Access Compliance Report

Public Rights-of-Way

(Curb Ramps)

Intersection ID: 5704	Main Street: W_W_T_HARRIS_BV	Cross Street: N_TRYON_ST	Location:	S
ADA ID: 19478BC5014A	Ramp Type: Directional1	Initial Pass/Fail: Fail	Overall Compliance: No	Severity Score: 12.5
Codes/Mitigation Info/Possible Solution		Field Measurements/Component Compliance

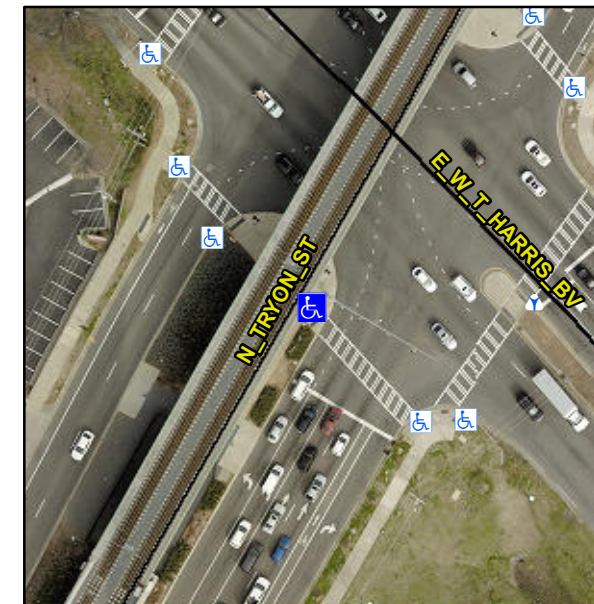
LOCATED ON MEDIAN

R304.2.2

Compliance	Description	Data	Compliance	Description	Data
N/A	Ramp Length (in)	76.0	N/A	Grade Break?	N/A
Yes	Ramp Width (in)	119.0	N/A	Grade Break Slope (%)	0.0
No	Ramp Slope (%)	11.2	N/A	Grade Break XSlope (%)	0.0
Yes	Ramp XSlope (%)	0.5			
N/A	Flare Type LT	N/A	N/A	Flare Type RT	N/A
N/A	Flare Slope LT (%)	N/A	N/A	Flare Slope RT (%)	0.0
N/A	Flare Traversable LT?	N/A	N/A	Flare Traversable RT?	N/A
N/A	Landing Length (in)	0.0	N/A	DWS Provided?	N/A
N/A	Landing Width (in)	0.0	N/A	DWS Contrast?	N/A
N/A	Landing Slope (%)	0.0	N/A	DWS Length (in)	N/A
N/A	Landing X Slope (%)	0.0	N/A	DWS Full Width?	N/A
N/A	Landing Curb? (Y/N)	N/A	N/A	DWS Offset LT (in)	N/A
N/A	Shared Landing?	N/A	N/A	DWS Offset RT (in)	N/A
N/A	Gutter Ponding?	0.0	N/A	Gutter Slope (%)	N/A
N/A	Gutter Lip Ht (in)	1.0	N/A	Gutter X Slope (%)	N/A
N/A	Painted X Walk1?	No		Road Slope (%)	3.5
	X Walk 1 Direction	To E		Road X Slope (%)	1.6
	X Walk 1 Width (in)	N/A		Clear Space?	N/A

Remove & Replace Entire Ramp.
